REMARKS

Serial Number: 10/823,666
OA dated 3/31/05
Amdt. dated 6/30/05

10/823,666
ANNOTATED MARKED-UP DRAWING

FIG. 1

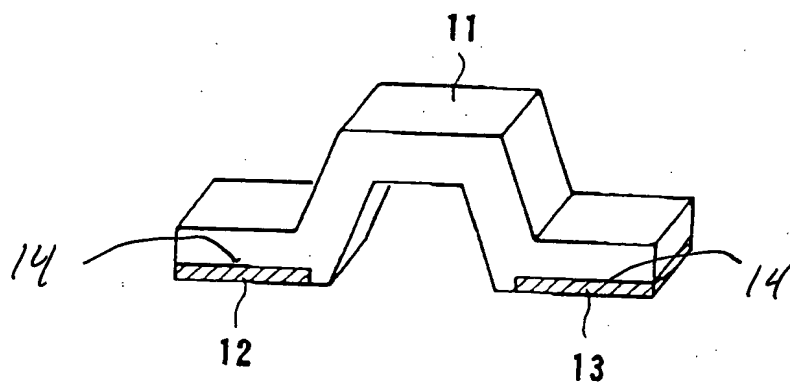
In the Office Action, the drawings were objected to as not showing all of the features being claimed. Specifically, it was alleged that the drawings fail to show the "grooves" as recited in claims 14 and 15.

Figure 1 has been amended to include the numeral 14 to identify grooves. An annotated marked-up drawing as well as a Replacement Sheet are attached herewith.

In response, Figure 1 of the drawings has been amended to include the numeral 14 for the two grooves. Additionally, lines 15-17 of page six of the specification have been amended to read as follows:

"In the case of the inlay cladding structure, it is necessary to pre-fabricate grooves 14 in the base material for inlaying the metal strips 12 and 13."
